Deviation Request ETSO-C115c#8 for an ETSO approval for CS-ETSO applicable to Airborne Area Navigation Equipment Flight Management Systems (FMS) Using Multi-Sensor Inputs (ETSO-C115c)

Consultation Paper

2 ETSO-C115c#9 Airborne Area Navigation Equipment Flight Management Systems (FMS) Using Multi-Sensor Inputs

FIGURE H-3 Waypoint with Vertical Constraint

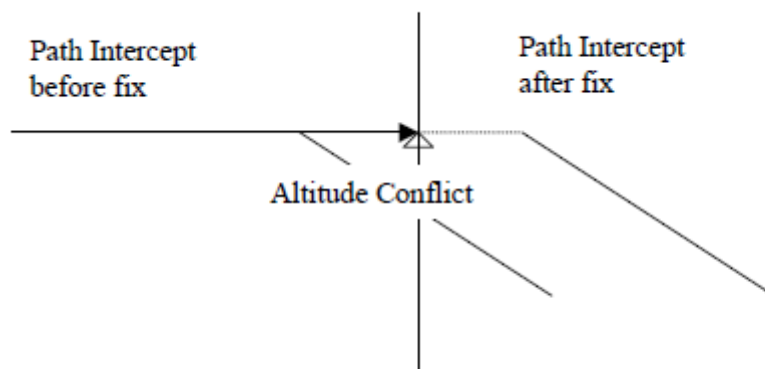
If an FPA vertical path intersects the altitude of a preceding three-dimensional (AT or AT/ABOVE) fix after the constrained fix, the system shall compute a level segment until interception the FPA path (See Figure H-3).

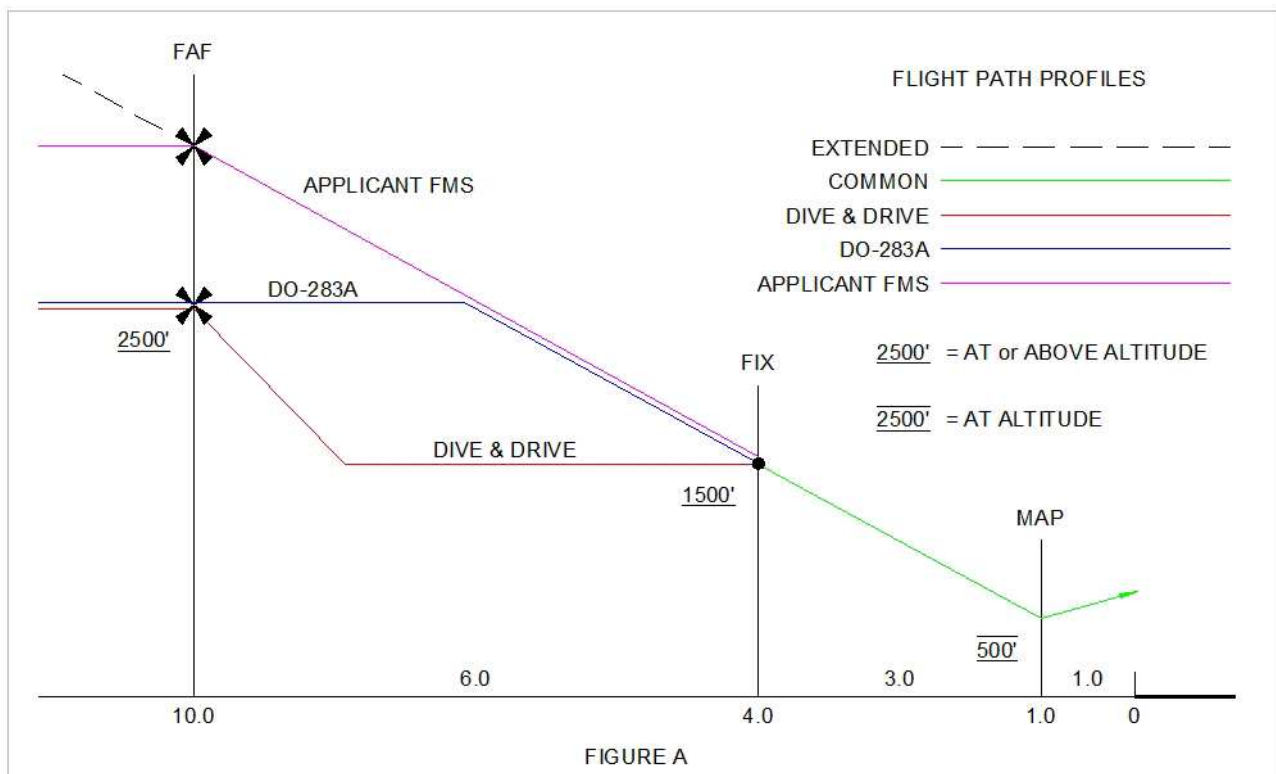
The situation depicted in figure H-3 of DO-283A (Figure A below) is handled by the applicant FMS by computing the actual crossing altitude of the flight path angle at the fix when the FAF constraint is an AT or ABOVE. If VNAV is used to fly to the point, the VNAV path is to the intercept altitude rather than the lowest altitude of the AT or ABOVE constraint.

The applicant FMS computes the crossing altitude for the Flight path angle path at the constraint location for the AT or ABOVE constraint case (Figure A). This clearly provides the equivalent safety as the level segment as the aircraft may follow VNAV guidance to this elevated point where ATC allows such an operation or use the flight guidance system to intercept level at the lower constraint altitude. For the AT constraint case (Figure B), the applicant FMS provides VNAV guidance to the path defined by the altitudes and waypoints. This is consistent with geometric point to point VNAV and is clearly understood by aircrews. The applicant FMS reasoning has been that on a typical approach with an AT altitude, aircrews were descending to the next constraint and then flying level (Dive & Drive), however, the FMS provides the path guidance to make the next constraint good. This has been the approach mode operation for many years.

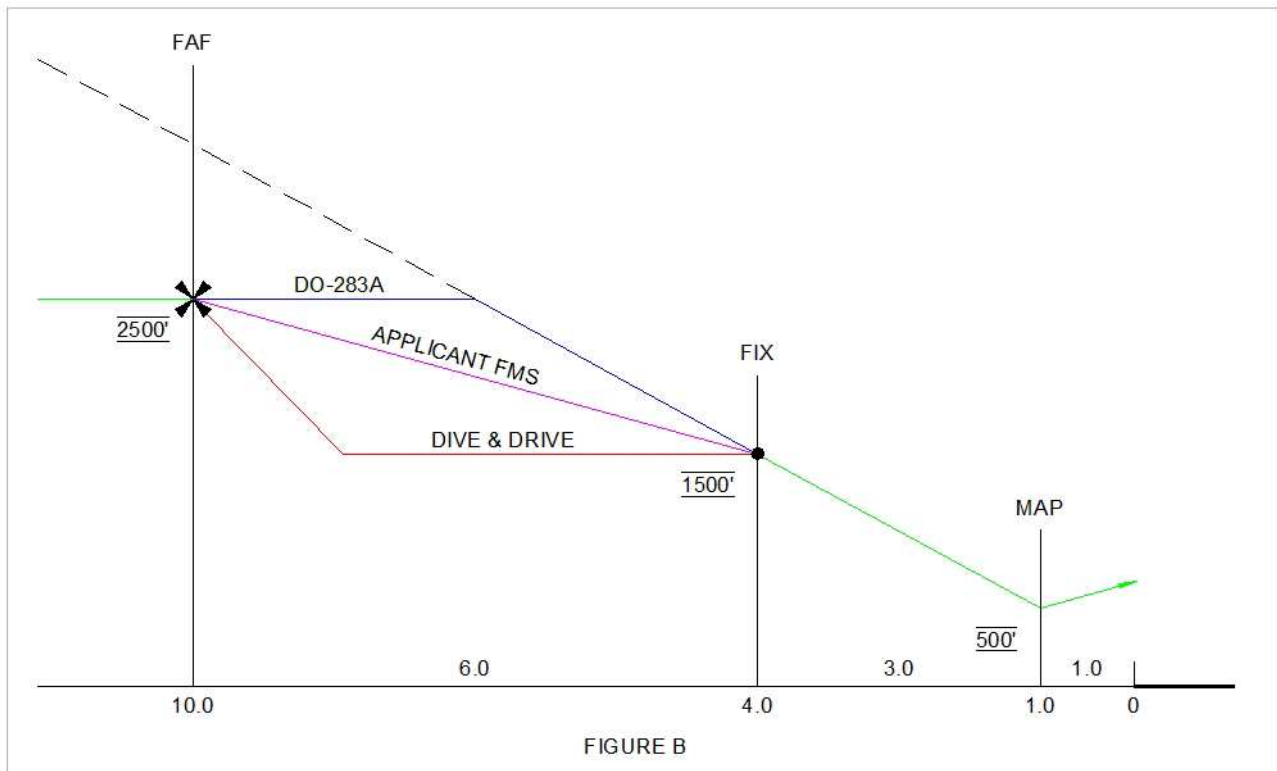
If the waypoint has an AT constraint (Figure B), the applicant FMS would construct the VNAV path to the next constraint as a geometric point to point path rather than as a 3 degree (or as specified) VNAV approach path.

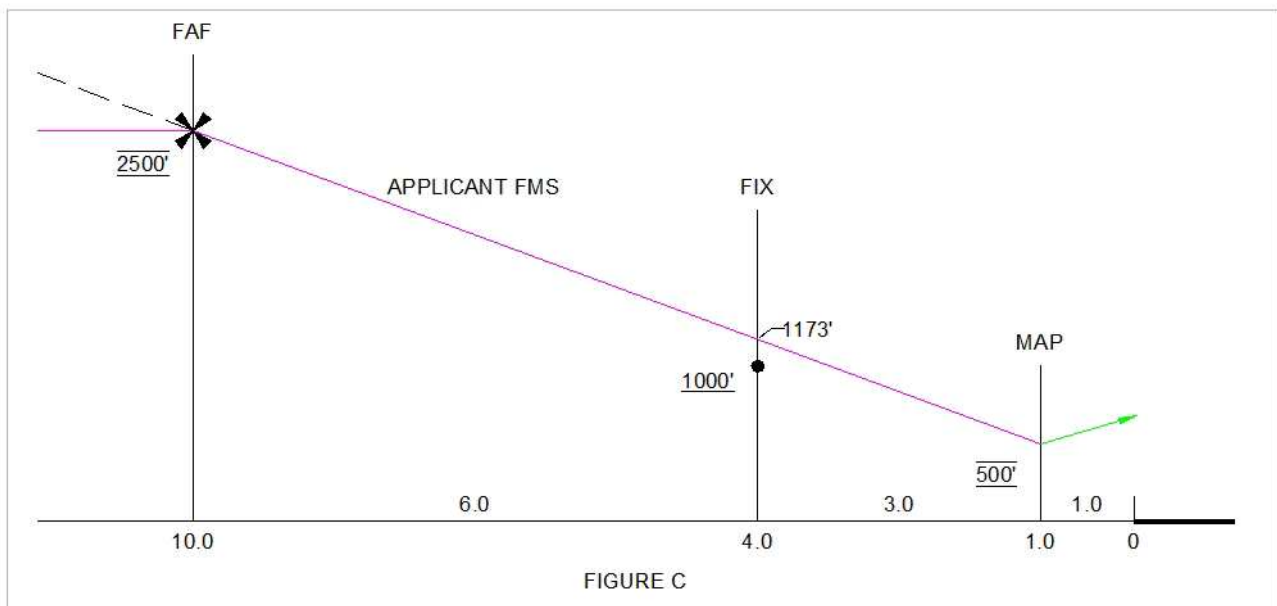
There are situations (Figure C) where step down fix altitude would be coded as “AT or ABOVE” causing them to be VNAV fly past waypoints. This situation typically occurs when the VNAV path (as defined by the FAF altitude and the MAP altitude) is calculated to be above the step down fix altitude. The FMS would then calculate a constant VNAV path honoring the minimum altitude at the step down fix and provide the flight crew with a constant VNAV path angle on the approach. This behavior has been in the applicant FMS products for a number of years now and has been evaluated extensively, and is consistent with typical industry implementations. In all cases, the applicant FMS honors step down fix published minimum altitudes.
